PERMIT ISSUED					SSLIED			
City of Portland, Maine - Building or Use Permit Application Permit No: Issue Date: Chl.								
		: (207) 874-8703	3, Fax: (207) 874-87	16	01-0467	MAY - o	39 BO	01001
Location of Construction	n:	Owner Name:			er Address:		Phone:	
125 Newton St Desanctis Marcus A &				125	Newton St Parity of	Ute BU	2 07-878-	7454
Business Name: Contractor Name:				Contr	ractor Address.	01 10	八十十十十十	
n/a		no contractor/	self	n/a ı			20787874	454
Lessee/Buyer's Name		Phone:			it Type:			Zone:
n/a		n/a		Ado	ditions - Dwellings			L-5
Past Use:		Proposed Use:		Perm	nit Fee: Cost o	of Work:	CEO District:	¬' -
			/ 8' x 8' deck w/ hot	1	\$30.00	\$400.00	1	
tub placeed sq			uarly on top.	FIRE	E DEPT: Appr	oveu	PECTION:	
					Denie	Lise	Group: 17.3	Type:5/
					_	م	AFBIXT IS	۱۱۱۲۲ کشانشده
P 10 1 10				_			را دورار حص	144
Proposed Project Descri Build 8' x 8' deck	iption:					- \		H/10
Build 8 X 8 deck			Signature: Signature			MA

BUILDING PERMIT REPORT

Proposed Spa Sub-deck Marcus DeSanctis 125 Newton St. Portland, ME 04103 207-878-7454

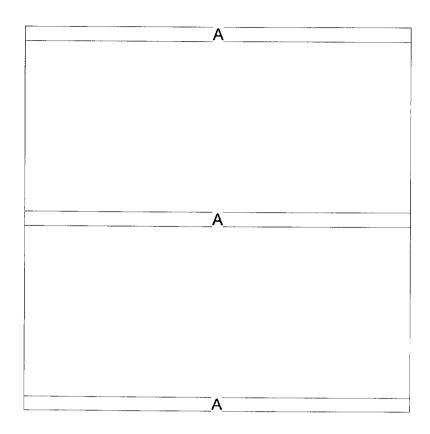
Joists to be toe-nailed to beams with 2-1/2" (8d) galvanized nails. Working, Sohn le 3-8d, Rim joists to be face-nailed to joists & ledgers with 3-1/2" (40.) Rim joists to be face-nailed to joists & ledgers with 3-1/2" (16d) galvanized nails. Blocking and bridging is not shown, but may be required by your local code.

5/23/01- Spake to owner on telephone and did pre-con In Joch - Nauls - Treads - Sonar Lubes ect ect - Tomm
